Tennessee Valley Authority, Post Office Box 2000, Soddy-Daisy, Tennessee 37379

October 11, 1995

SEQUOYAH NUCLEAR PLANT (SQN) - REQUEST FOR APPROVAL OF ALTERNATIVE TO AMERICAN SOCIETY OF MECHANICAL ENGINEERS (ASME) CODE REQUIREMENTS - CANOPY SEAL WELDS - UNIT 1

ENCLOSURE

Figure 3.2-1. Cutaway of a Typical Control Rod Drive Mechanism

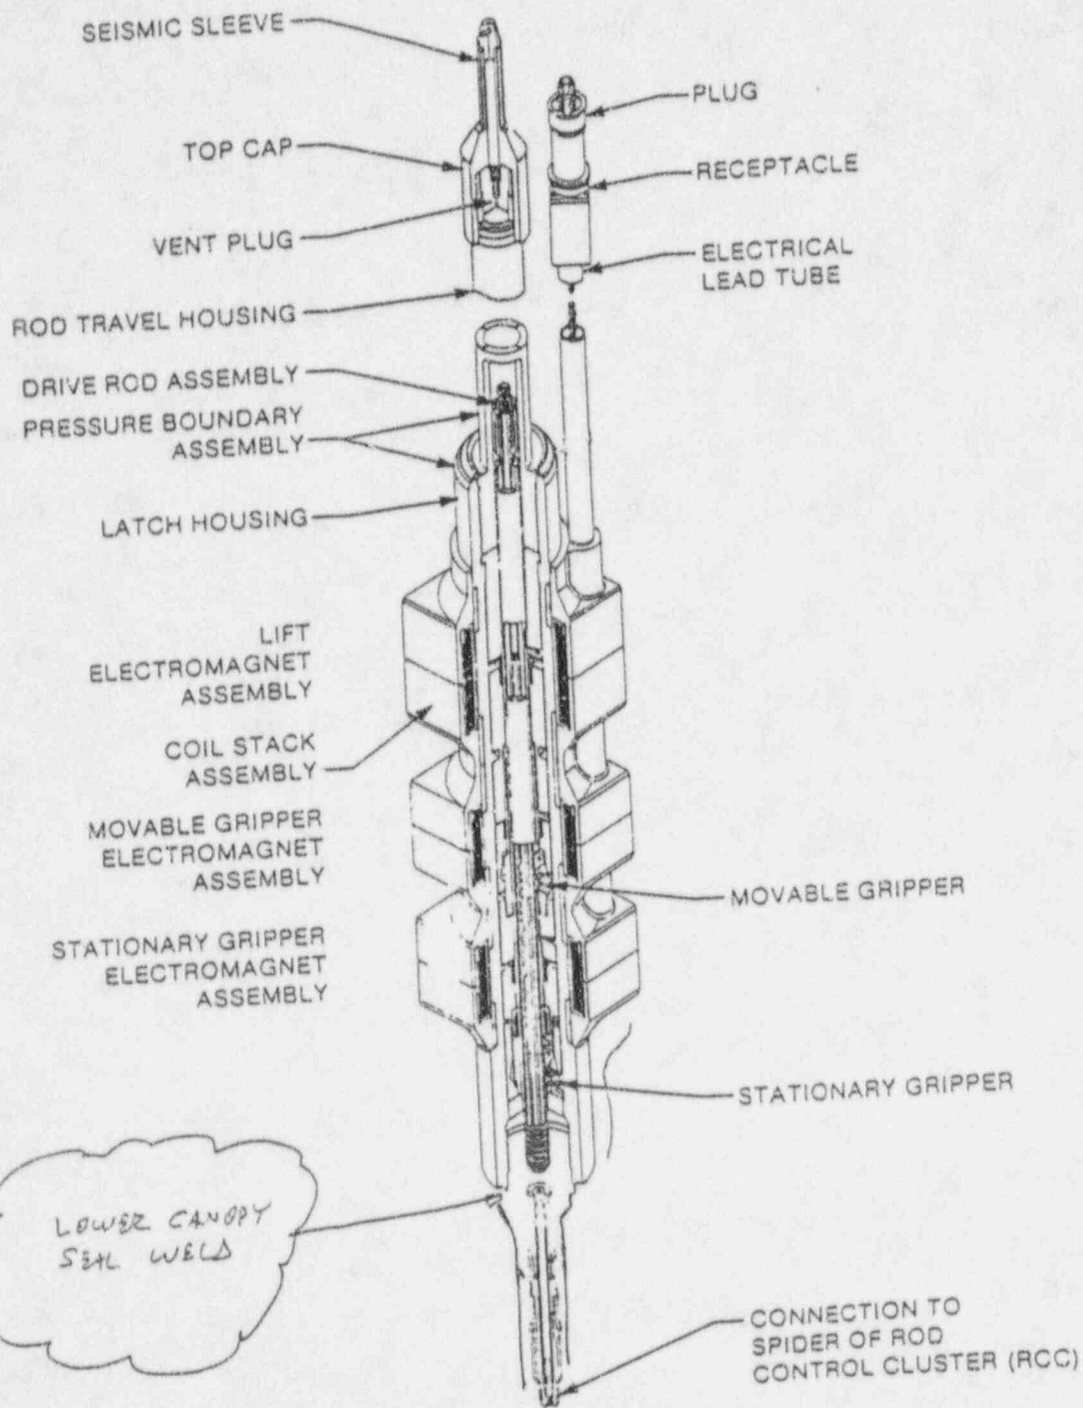
Background: During the Unit 1 Cycle 7 refueling outage activity of disassembling the reactor vessel, boric acid residue was noticed on a control rod drive mechanism (CRDM). Further inspection shows that two CRDMs and one thermocouple penetration have started leaking at the lower canopy seal weld (see Attachments 1 and 2).

Requirement: TVA's Code of Record for Repairs and Replacements is ASME Section XI, 1980 Edition through the Winter 1981 Addenda. TVA proposes to use Code Case N-389, which allows the use of later code editions and addenda of Section XI. Code Case N-389 is approved for use in the latest revision of Regulatory Guide 1.147. IWB-3640 and Appendix C of the 1989 Edition of ASME Section XI is used to perform the required fracture mechanics and to design a weld overlay repair of the flawed canopy seal weld. Code Case N-504-1 is also used for guidance. Code Case N-504-1 allows repair by addition of weld material without removal of the underlying defect to be considered as a code repair. IWB-3640 provides criteria for acceptance of flaws without repair in ductile, austenitic materials. The basis for such acceptance is the evaluation of the structural adequacy of the flawed component after considering the predicted flaw growth over the evaluation period. The acceptance criteria is based upon the net section collapse (limit load) criteria which are defined in detail in Appendix C of Section XI. Also, NUREG-0313, Revision 2 is used for guidance. The repair design is based upon conservative treatment of applied stresses, and includes allowance for continued flaw growth, as required by Section XI.

The material used for the repair is Alloy 625 weld material, which is stronger than the underlying base material, more resistant to degradation mechanisms such as stress corrosion cracking, and is highly ductile. The load carrying capability of the repaired location is greater than the original component.

Dye-penetrant examinations that are required by NB-5271 will not be performed due to the space limitations, which prevent examiners the needed access to successfully perform the examination. As an alternative examination, TVA will use a remote video camera with a magnification of approximately 8X to 10X and perform a visual examination of the final weld at the enhanced magnification. The entire process of the repair will be recorded on video tape. The basis for this approach is that postweld dye penetrant examinations are surface examinations, and provides minimal assurance of repair integrity when compared to an enhanced visual examination. Additionally, fracture mechanics analyses demonstrate that

Figure 2-1. Schematic Illustration of Canopy Seal Weld Configuration

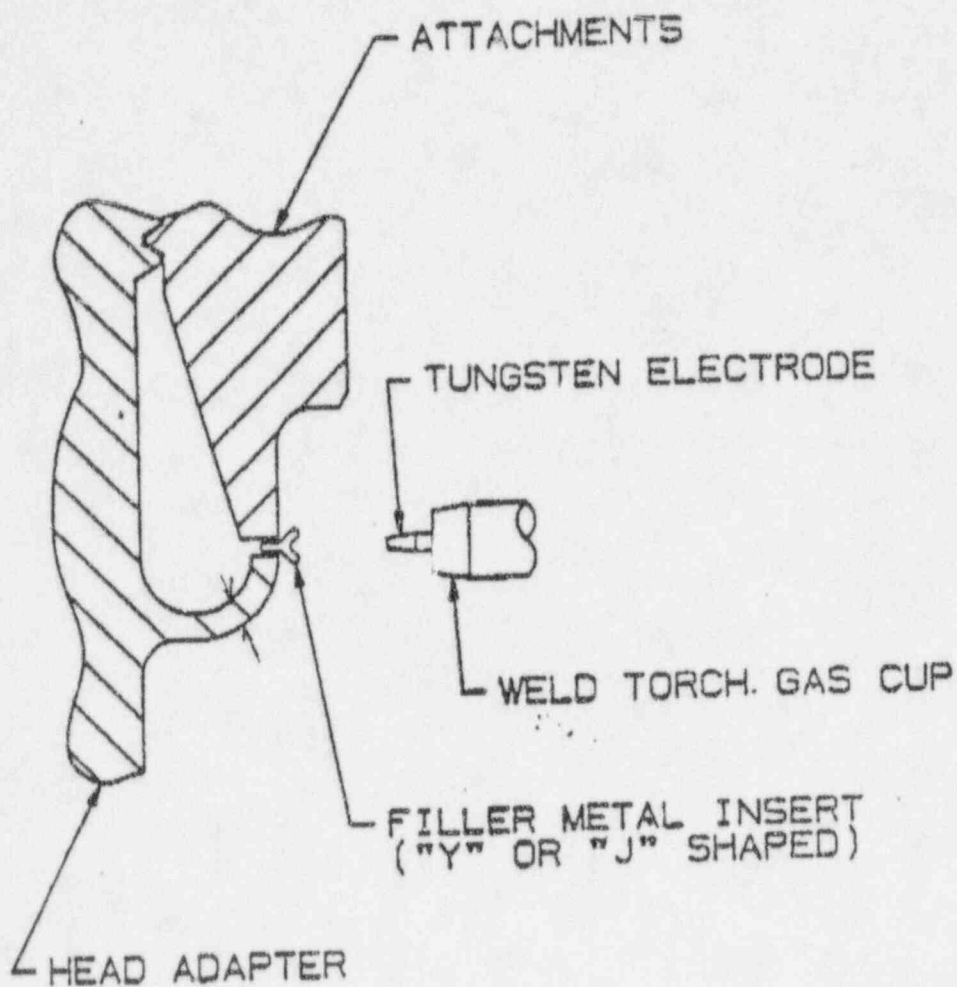
The CRDMs and a thermocouple penetration are fabricated in sections with threaded joints providing the pressure-retaining capabilities. Since the threaded joint provides pressure retention, the canopy seal weld is not pressure retaining and is for leakage control. The 1968 Edition of ASME Section III does not specifically address (either allowing or disallowing) these types of joints. Later editions of ASME Section III address threaded joints and do not allow them as the only seal as described in NB-3671.3. NB-3227.7 addresses the design of canopy seal welds. NB-5271 requires that seal welds receive either a magnetic particle or liquid penetrant examination.

Requirement: Due to physical space limitations and in consideration of as low as is reasonably achievable (ALARA), the flaws found by visual inspection cannot be removed. In addition, if the flaws were removed, it would be impossible to reproduce the configuration of the material as required by the design in order to restore the canopy seal back to its original design condition as required by IWA-4000 and IWB-4000.

the critical flaw size (i.e., the flaw size, which would lead to the incipient collapse of the repair under code allowable applied stress conditions) is significantly larger than a flaw that would be reliably detected by the enhanced visual examination.

The fracture mechanics analyses assume that an initial flaw is completely through the repair membrane. Thus, there is a large margin in the analyses. TVA considers the fracture mechanics analyses, coupled with the enhanced visual examination, suitable to provide an acceptable alternative to the code required dye penetrant examination.
